SUBJECT: REVIEW OF A TECHNICAL MEMORANDUM - PURSUANT TO

CALIFORNIA WATER CODE SECTION 13304 CLEANUP AND

ABATEMENT ORDER NO. R4-2021-0079

SITE: SKYPARK COMMERCIAL PROPERTIES (ASSESSOR PARCEL NO.

Attachment 1 - Figure 6 - Plume Margin ZVI Barrier

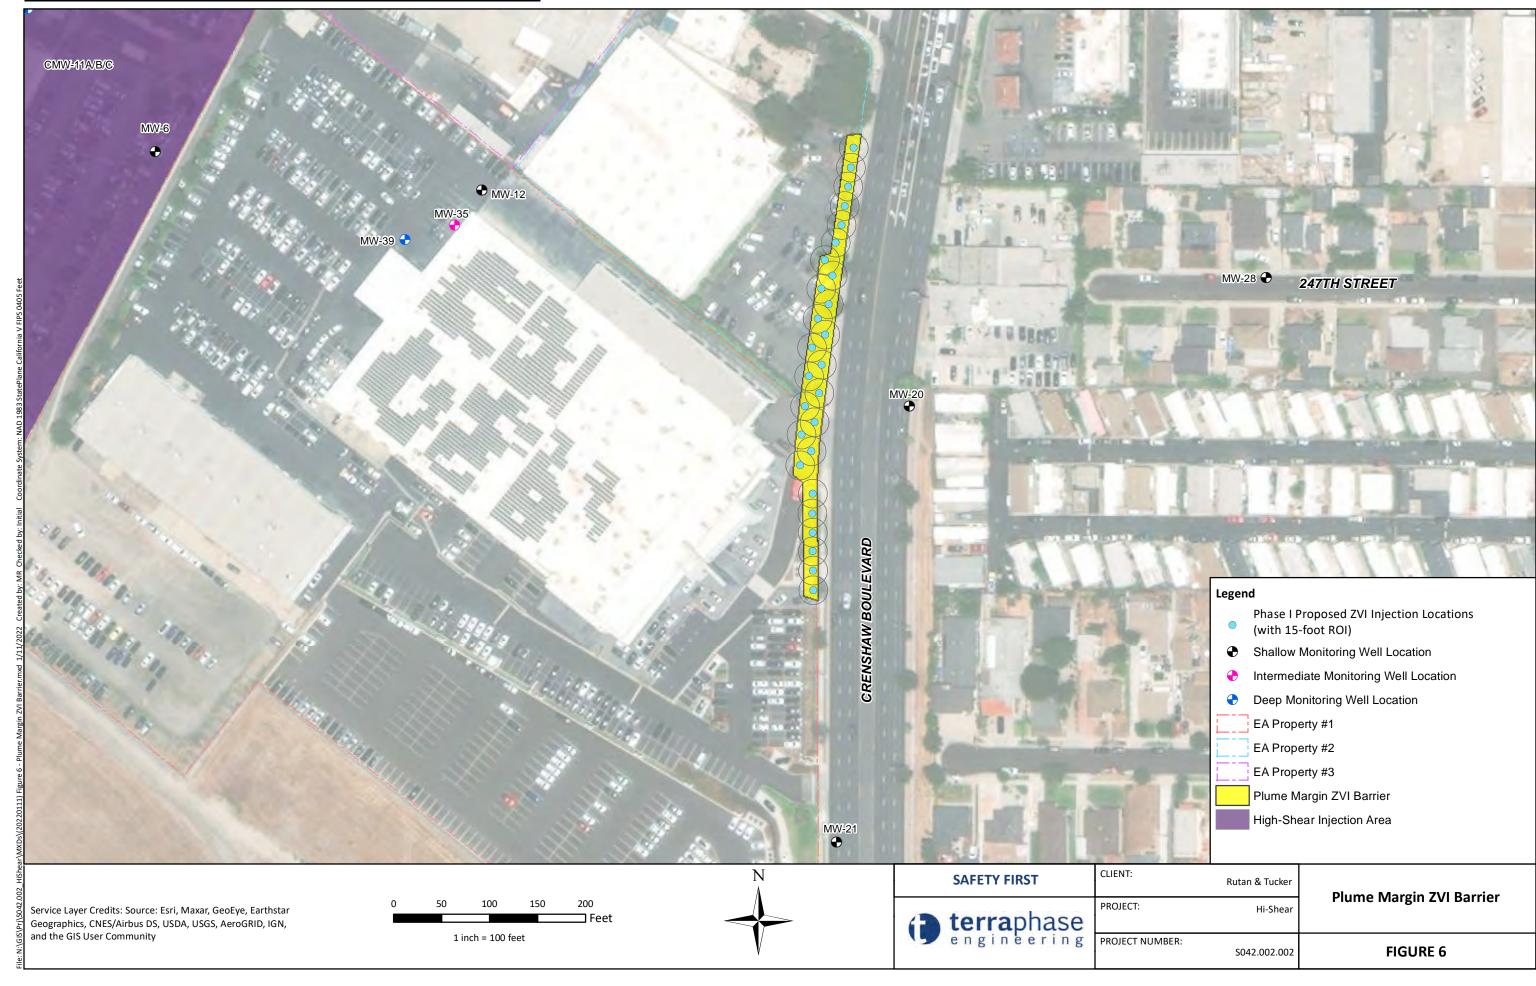
- a. Intends to minimize the migration of the VOC plume into the City of Lomita and to reduce groundwater contaminant concentrations.
- b. Is located roughly along the eastern boundary of the Site (i.e., along Crenshaw Boulevard) and measuring approximately 500 feet (see attached Figure 6 Plume Margin ZVI Barrier) to treat groundwater total VOC concentrations greater than 200 micrograms per liter (µg/L).

- 6. In addition to the proposed criteria of treating groundwater total VOC concentrations greater than 200 μg/L, the north and south ends of the ZVI barrier shall also be extended along the eastern boundary of the Site, as necessary, to address groundwater VOC concentrations that exceed one order of magnitude of their respective MCLs. The extension of the north and south ends of the ZVI barrier shall be based on the proposed confirmation groundwater sampling during the ZVI barrier installation and data from the investigative component of the EAP IRAP (i.e., grab groundwater sample data from the transects).

<u>Attachment 2 - Figure 5 – High-Shear Injection Well Locations</u>

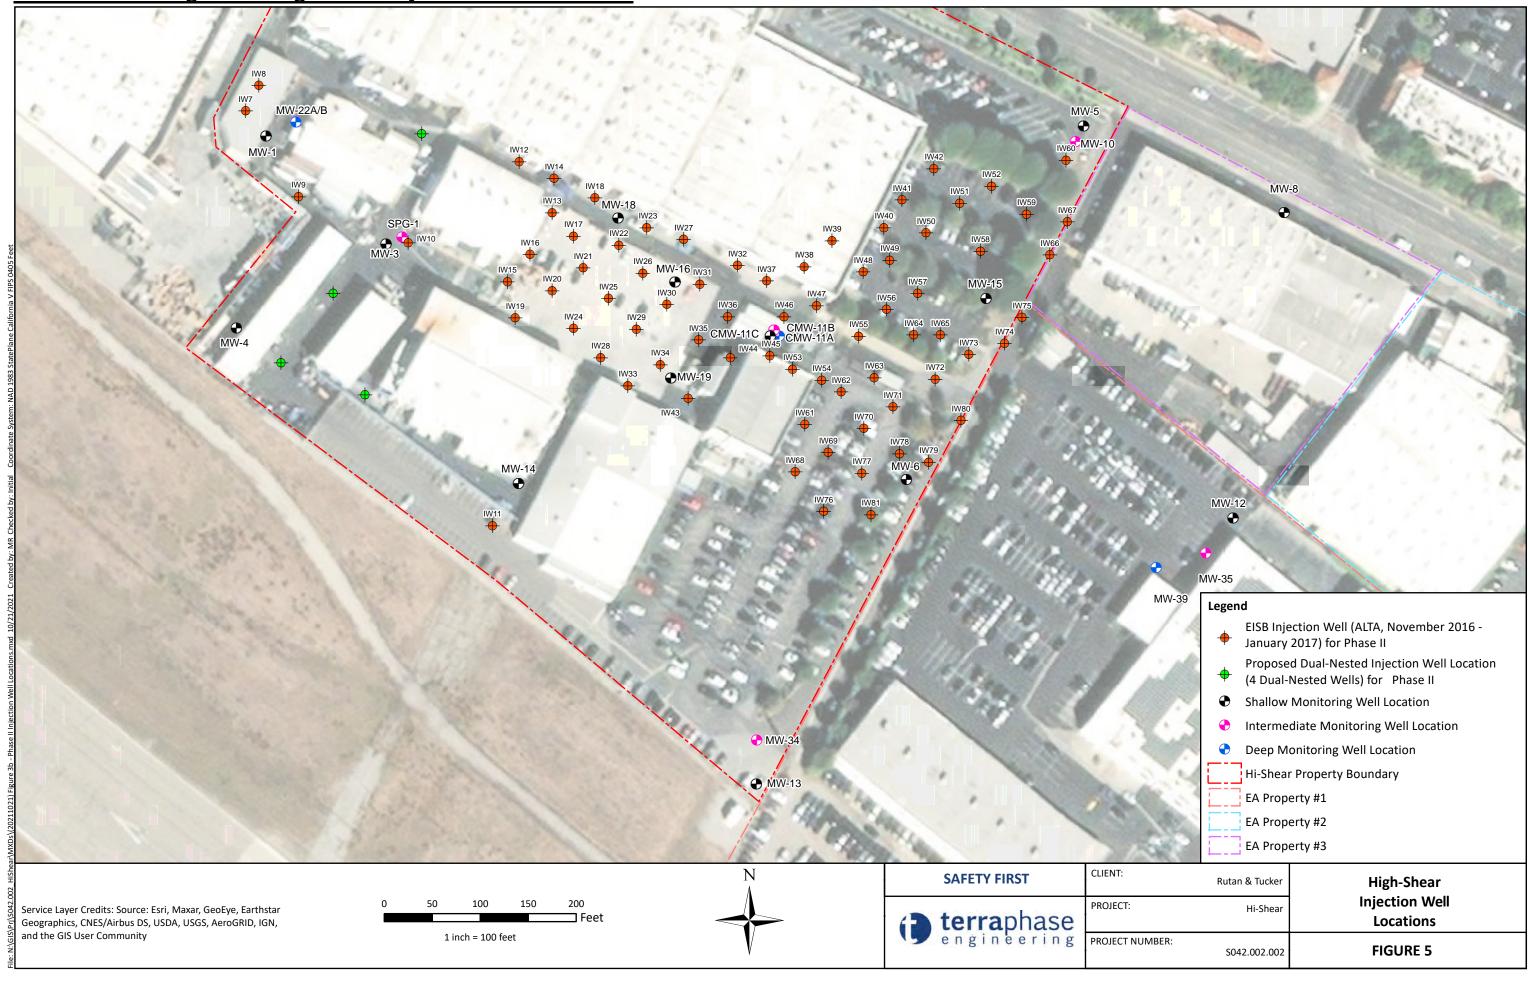
- c. Utilizes the existing 77 dual-nested injection wells, screened from 88 to 98 ft-bgs and 103 to 113 ft-bgs, at the Hi-Shear Property to reestablish and maintain a biologically active zone conducive for dechlorination (see attached Figure 5 High-Shear Injection Well Locations).

These injection wells shall be installed in a similar construction and configuration as the existing injection points and incorporated in the implementation of the Groundwater IRAP.

- The existing dual-nested injection wells that are deemed to be in poor working or nonworking conditions during inspection shall be rehabilitated or replaced with a new injection well of the same construction and configuration.
